**Sent:** 22/05/2023 3:48:58 PM  
**Subject:** 1162 Pittwater Road, Collaroy - Submission (DA2022/1153)  
**Attachments:** VIA 1162, Pittwater Road 5.2023 (1).pdf;

# VISUAL IMPACT ASSESSMENT

Objection to a Development Application  
No.1162, Pittwater Road, Collaroy.

**Development Application, No.1162, Pittwater Road, Collaroy, NSW.  
Visual Impact Assessment Report, May, 2023.**

Figure 5: Drawing from Complete Thought Studio, with red overlay showing extent of non-compliance with the DCP.

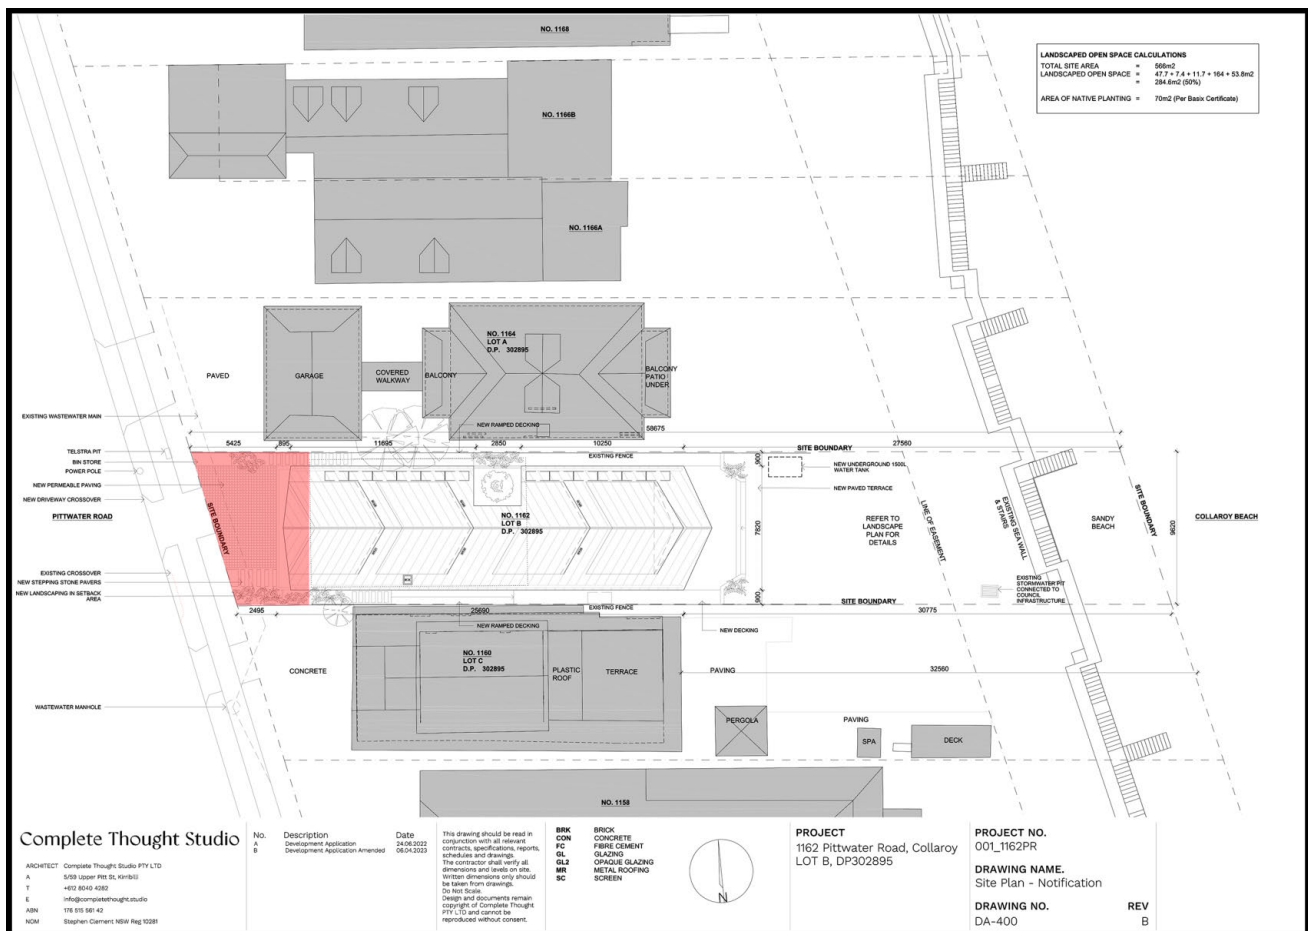
Additionally, the proposal can be deemed specifically non-compliant in relation to the Warringah Development Control Plan (DCP). This requires a front boundary setback of 6.5m. The current proposal has a setback of 2.8m – a 58% variance from a complying design. This will have relevance when Step 4 of the Tenacity Judgement is reviewed later in this assessment.

The proposed building is largely compliant with the DCP and LEP controls in terms of height limits and FSR. However, the design of the built form creates a building of excessive visual scale and bulk, with articulated elements that contribute to unnecessary view loss to neighbouring properties. The scale and bulk will also, likely cause excessive overshadowing onto the neighbouring properties. However, in the revised drawing set from Complete Thought Studio, shadow diagrams have not been prepared in accordance with Council Guidelines. The only shadows presented are from June 21<sup>st</sup> at 9am, midday and 3pm. There should be hourly shadows shown, from 9am to 3pm at 3 designated times of the year. Additionally, the view loss assessment images are not prepared in accordance with statutory guidelines, being those imposed by the LEC: Guidelines for the Preparation of Photomontaged Images. Their accuracy and usefulness cannot therefore be determined for the assessment of view loss, which is the most contentious issue with this application.

The positioning of the new development on the site ignores the rear alignment of the neighbouring buildings and appears to be an attempt to create total privacy for the subject site, at the expense of diminished views from the two neighbours to the north and south of the subject site. There appear to be many areas within the overall planning of the new proposal, where a more skillful design would mitigate view loss to the immediate neighbours, outlined later within this report.

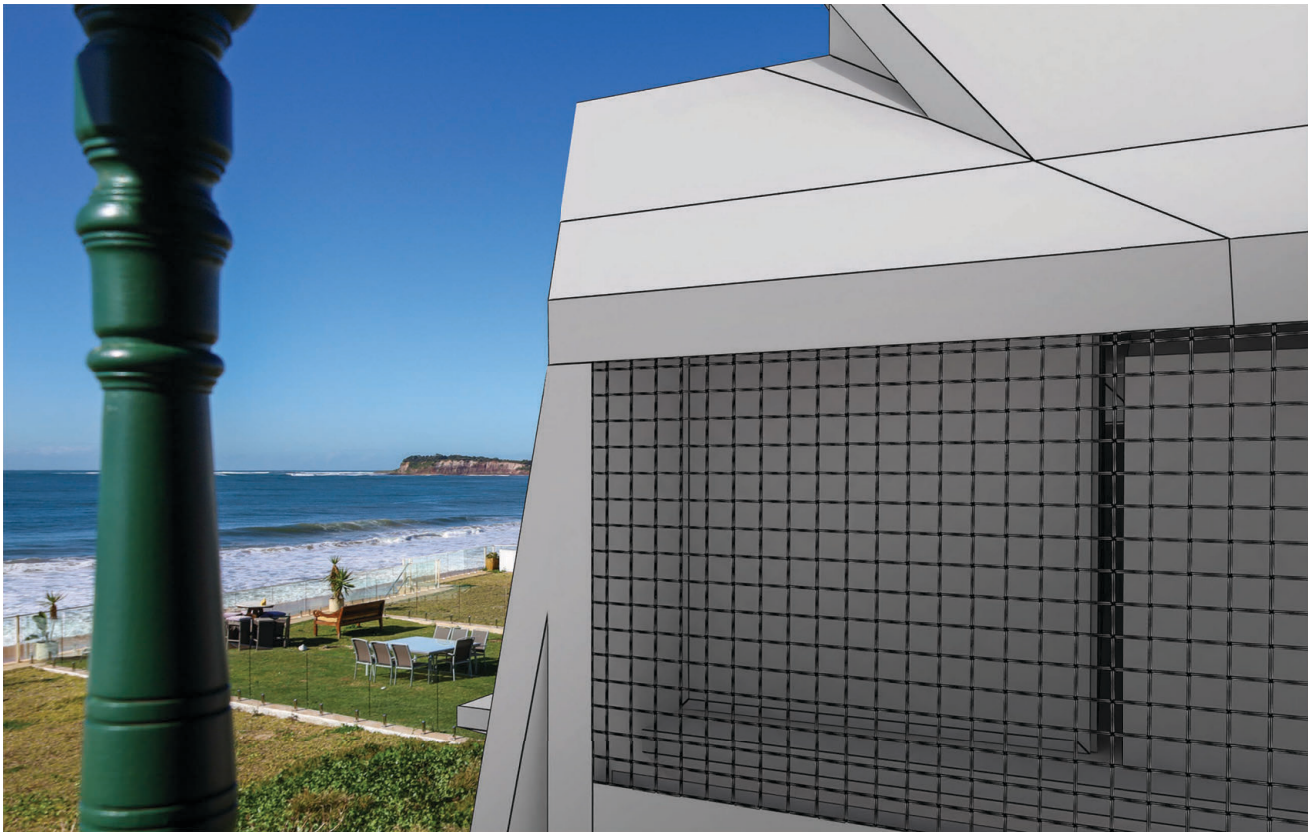
Visual impact – Amount of new building visible in view – 8%

Visual impact ratio of view loss to sky view loss in visible portion. 21%: 79%

Existing Visual Quality Scale no: 9 /15 Visual Impact Assessment Scale no: 12 /15

This is a static, private viewpoint from the living room interior of the ground floor of No.1164, Pittwater Road. The existing view is in a south- southeasterly direction to The Collaroy. Basin, with Long Reef Point beyond. To the west of these features, partially visible in this view, are Fishermans Beach and the main expanse of Collaroy Beach.

The new proposal impacts upon the entirety of the Headland from this viewpoint, including ocean views to Collaroy Basin below.

The view loss, in the context of available views from this location, would be considered Severe under the assessment guidelines of the Tenacity Consulting v Warringah Council [2004] NSWLEC 140 case, because of the iconic nature the Long Reef Point Headland. The view loss is caused by the easterly site location of the new proposal and its decorative raked concrete columns at the eastern most end and by the northern wall and roofline behind and above this.

Extent of impact: Severe.

Reasonableness of proposal: This is a non-compliant building that presents an excessive scale and bulk to the adjoining properties, causing significant visual impact. View loss is unacceptable and the proposal is unreasonable.

Current and proposed eastern perimeter of development proposal.

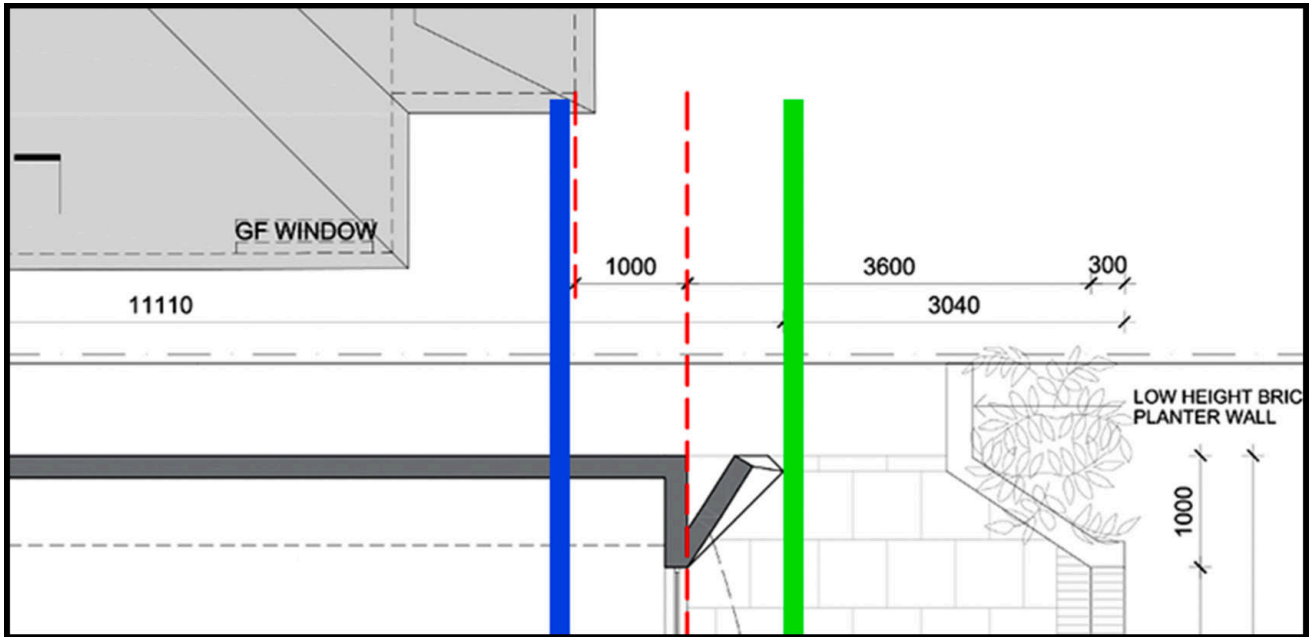
In relation to view loss, there is one very specific area that should be addressed. The rear of the building is indicated within the architectural drawing set with a dotted red line, see below. However, beyond this line is a significant, decorative concrete structure that forms a sloping blade to the rear elevation – see green boundary line, below. This alone causes significant view loss to both adjoining neighbours and appears to serve little practical purpose, other than creating further privacy for the residents, at the expense of the amenity of the neighbours.

A more reasonable solution, in terms of retaining the amenity of the neighbouring residents, is shown above. The dotted red line indicates the rear glazing line of the proposal, indicated within the architectural drawing set. The green line, to the east, shows the extent of the visual obstruction caused by the concrete decorative blades.
